SERVICE BULLETIN

Fecha: 08/06/07
Referencia: SB-DAITSU-001
PAG. 1/2

Producto: Split Pared On/Off DAITSU
Ref. fabricante: DS12HTA _ DOS12HTA
Código: 3NDA8020 – VL0
Marca: **DAITSU**

ASUNTO: Modelos distintos con misma referencia fabricante. Unidad interior DS12HTA y unidad exterior DOS12HTA.

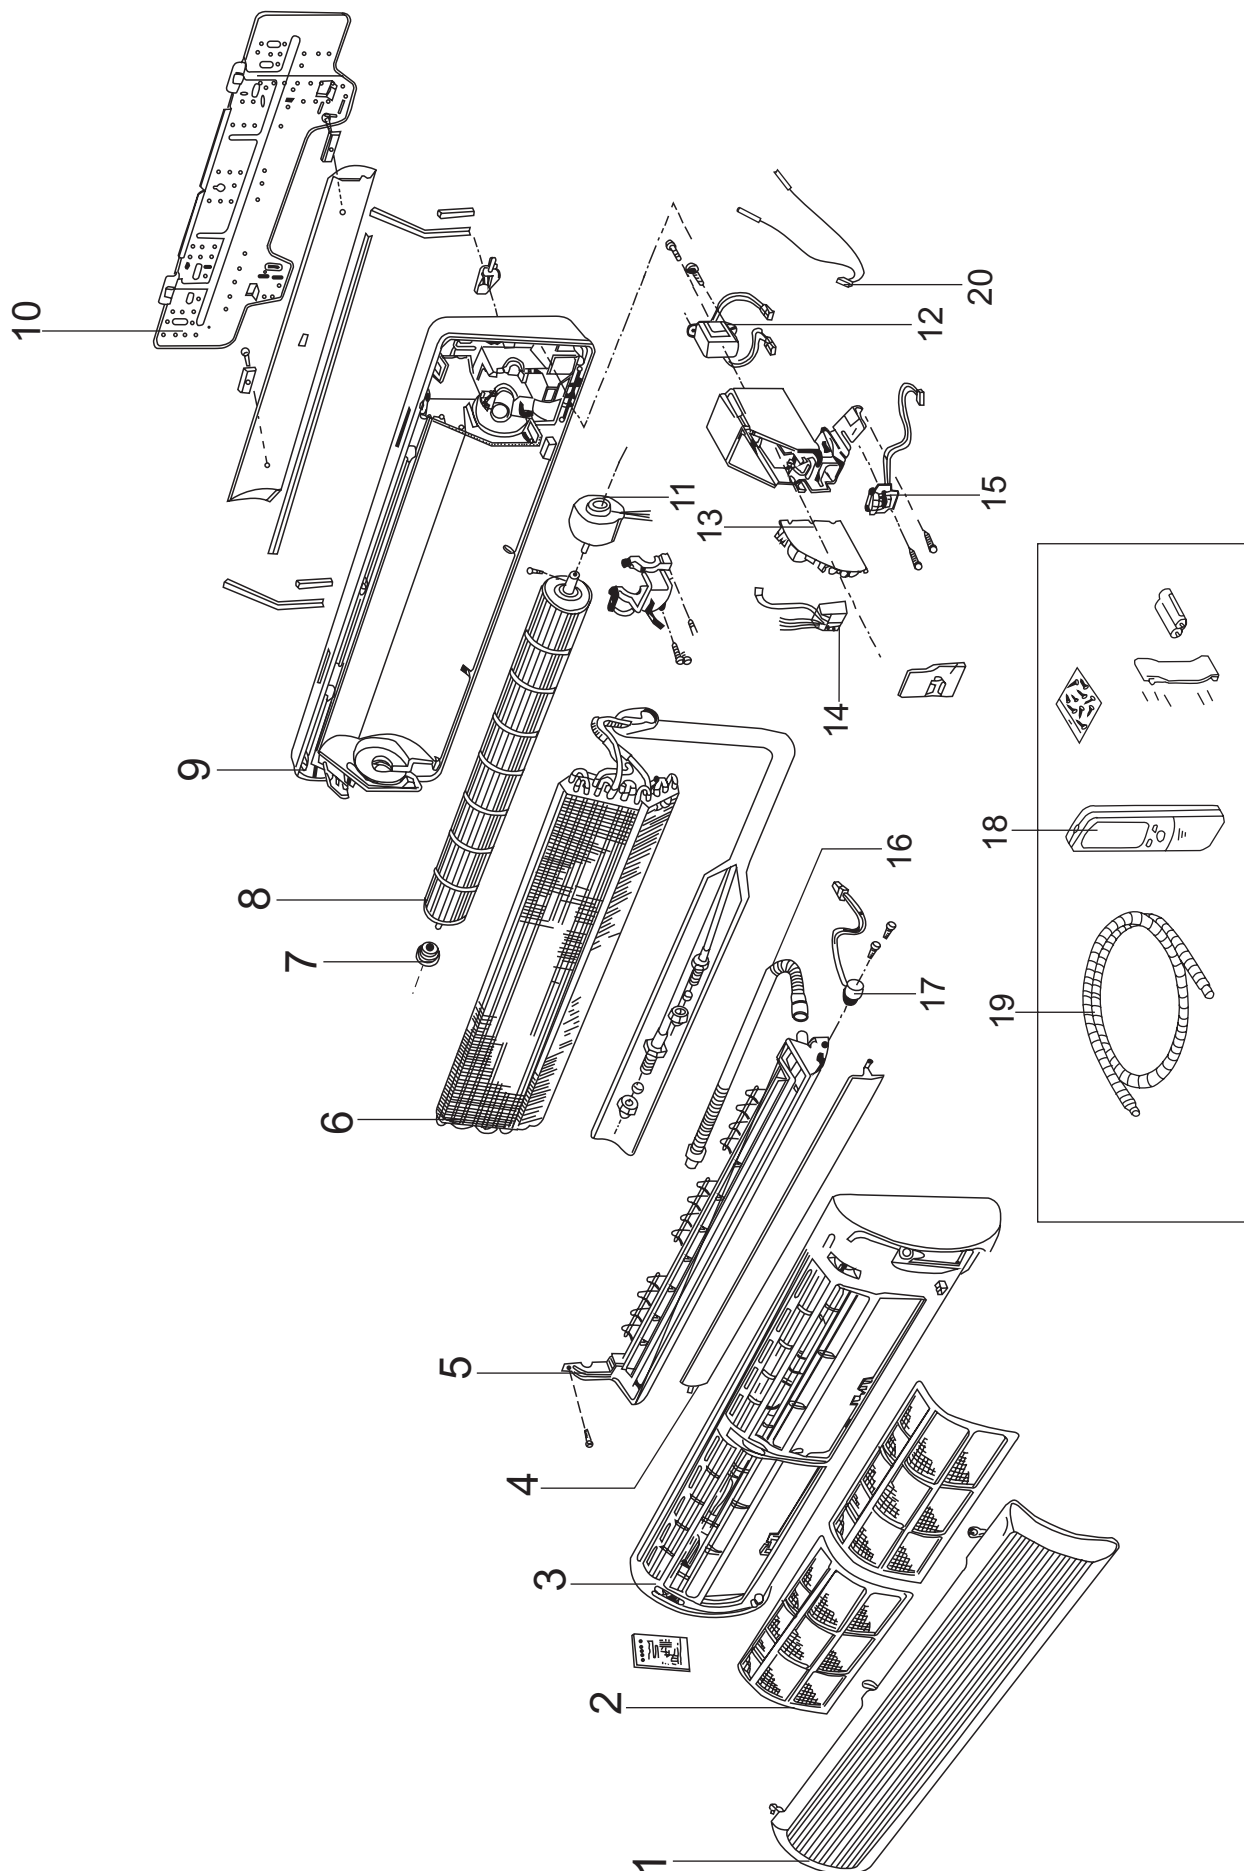
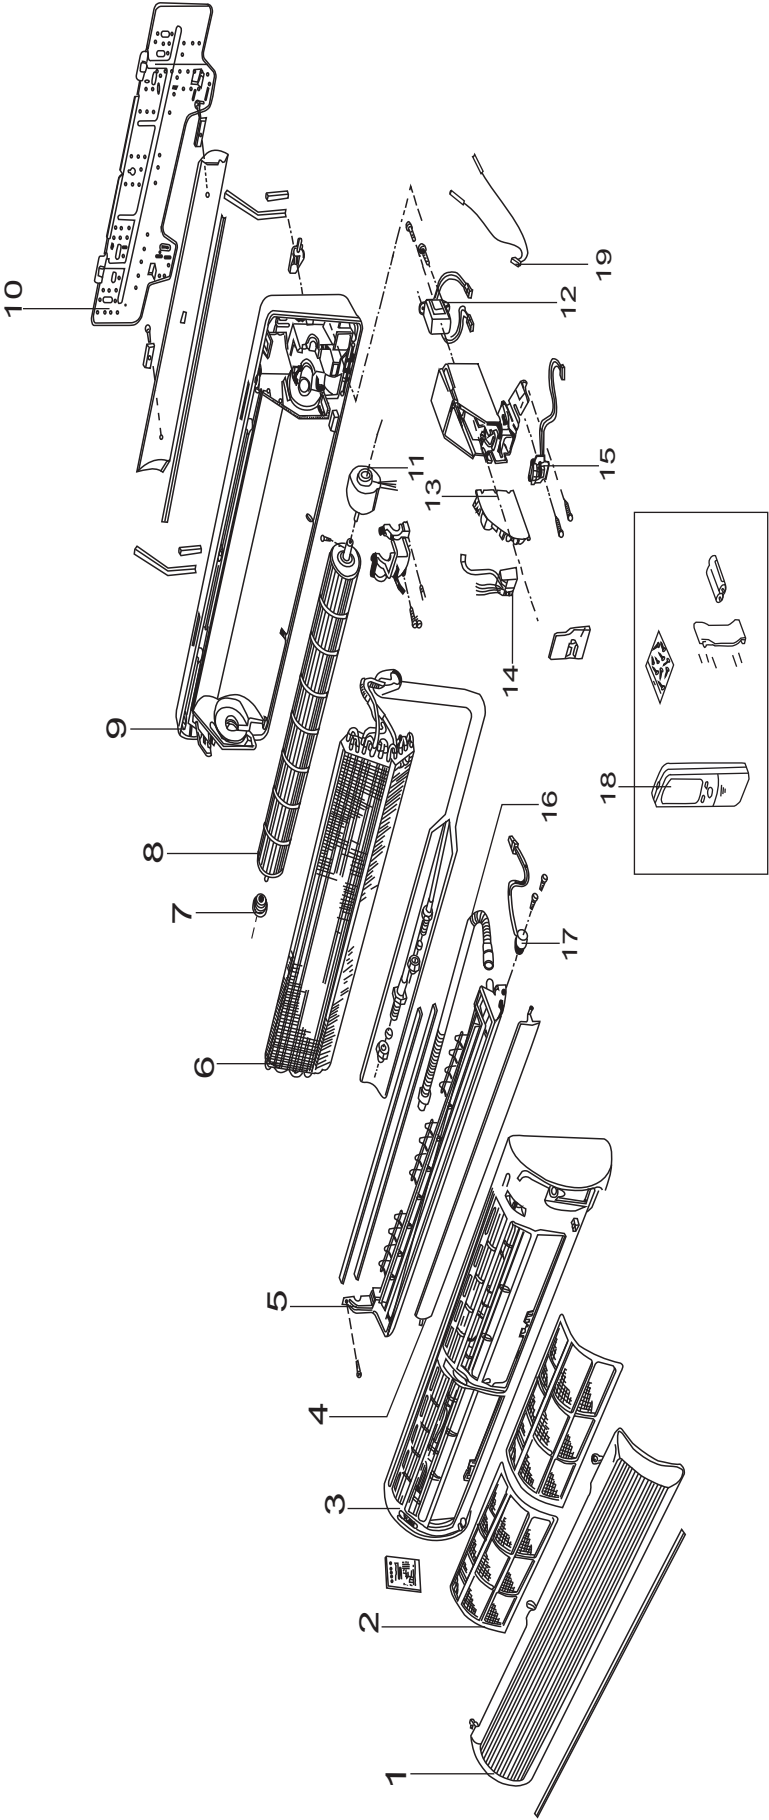
Para el modelo 3NDA8020 VL0 tenemos dos modelos diferentes de máquina con la misma referencia DS-12HTA / DOS12HTA. Un modelo fabricado en el año 2005 y el otro en 2007.

La mayoría de los componentes principales son diferentes, por lo que cuando llame un cliente preguntado por un recambio será necesario preguntar por el número de serie de la unidad. Este aparece en la placa de características de la unidad interior y exterior

- modelo de 2005: AA5SK0E0C00
- modelo de 2007: AA6F31E0600
